SUBDIVISION REVIEW SHEET**CASE NO.:** C8-2022-0257.0A**COMMISSION DATE:** October 18, 2022**SUBDIVISION NAME:** Regiene Subdivision**ADDRESS:** 6501 Regiene Road**APPLICANT/AGENT:** Rita Wersich (WGI)**ZONING:** LI-PDA-NP/LI-CO-NP**NEIGHBORHOOD PLAN:** MLK -183**AREA:** 20 acres (878,354 sf)**LOTS:** 9**COUNTY:** Travis**DISTRICT:** 1**WATERSHED:** Boggy Creek**JURISDICTION:** Full Purpose**VARIANCE:** None**DEPARTMENT COMMENTS:**

**CITY OF AUSTIN –DEVELOPMENT SERVICES DEPARTMENT
SUBDIVISION APPLICATION – MASTER COMMENT REPORT**

PROJECT NAME: Regiene Subdivision
LOCATION: 6501 REGIENE RD

Date:	7/25/2022
Project:	01049
Scale:	1" = 100'
Reviewer:	SD
Tech:	AK
Field Crew:	JO/WC
Survey Date:	JAN. 2021
Sheet:	1 OF 4

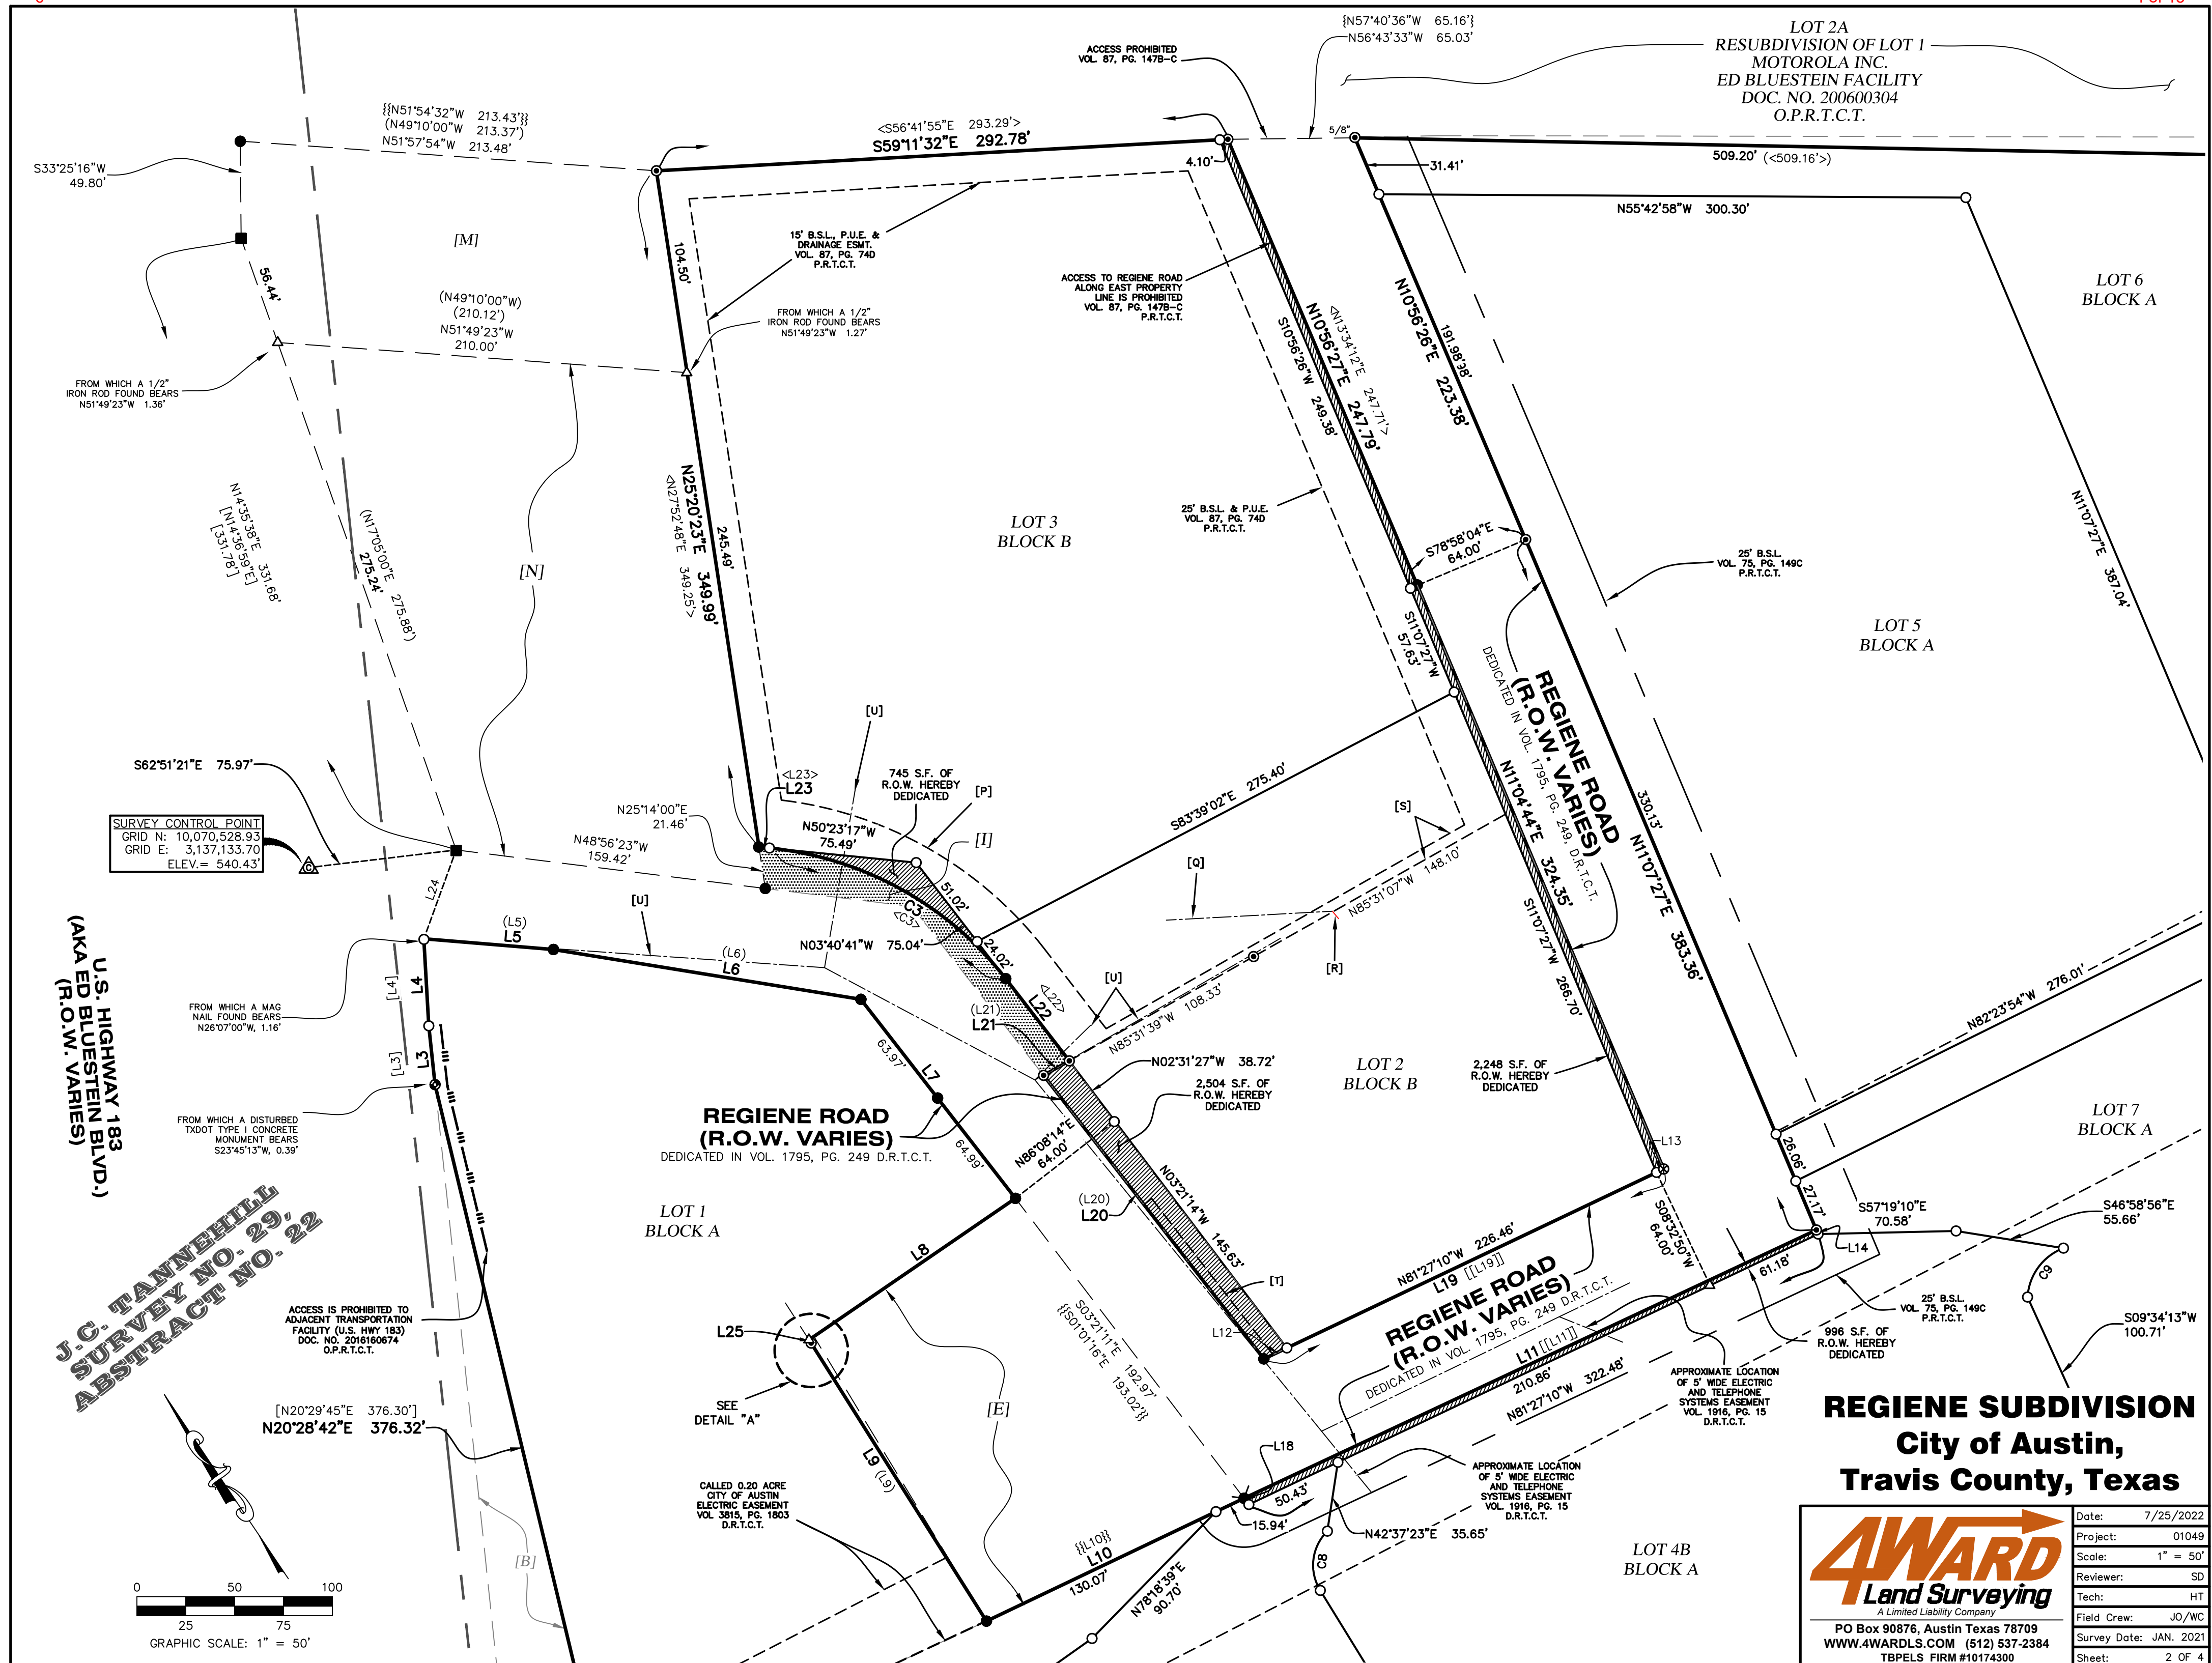
AD2: Please remove the label for U.S. HIGHWAY 183 and replace it with ED BLUESTEIN BLVD NB as it reads here on sheet 1 and sheet 2. AKA should not be included as part of the street name for ED BLUESTEIN BLVD NB and no parenthesis should be included for ED BLUESTEIN BLVD NB

AD4: Include the three street labels for REGIENE ROAD within the ROWs on sheet 1, similar to the street labels on sheet 2. Include the street label of REGIENE ROAD between LOT 1, LOT 2 and LOT 3

AD7: Please include the street label of HIBBETTS RD on sheet 1 and sheet 2. See snapshot below:

- ATD 6. Sidewalks are required on the subdivision side of ED BLUESTEIN BLVD NB. Identify the location of the sidewalks by a dotted line on the final plat and include the sidewalk symbol within the legend. LDC 25-6-351. TCM, 4.1.1.

- ATD 7. Sidewalks are required on both sides of REGIENE RD. Identify the location of the sidewalks by a dotted line on the final plat and include the sidewalk symbol within the Legend. LDC 25-6-351. TCM, 4.1.1.

VICINITY MAP

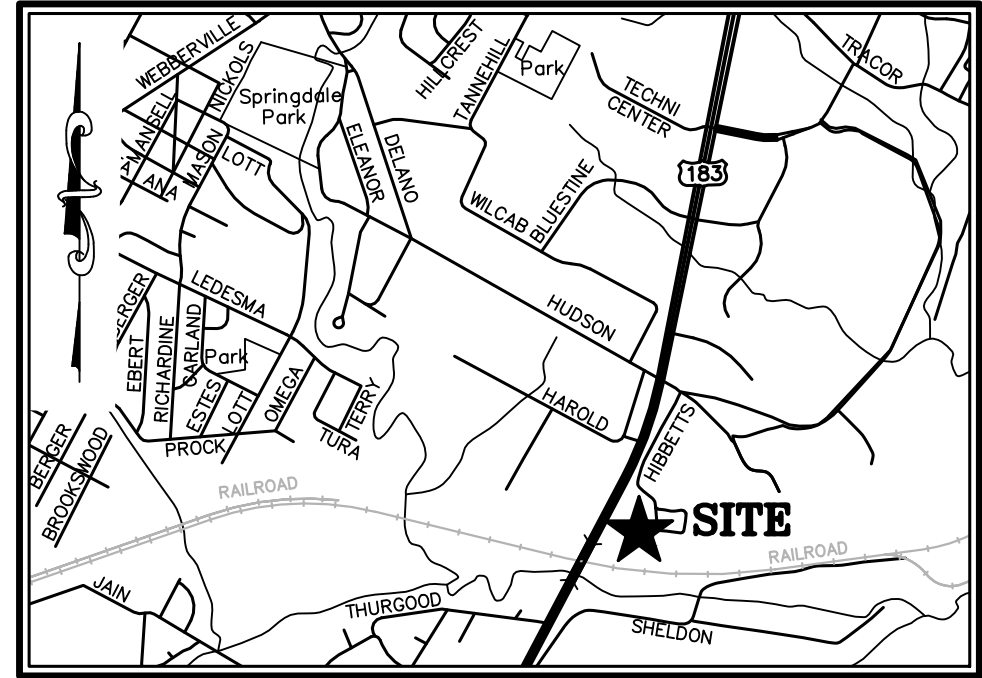
AD5: In the vicinity map replace BLUESTINE with BLUESTEIN DR as it reads here.

AD6: In the vicinity map remove the 183 label and replace it with ED BLUESTEIN BLVD SB as it reads here. Please add this label west of the street segment as shown in the snapshot below.
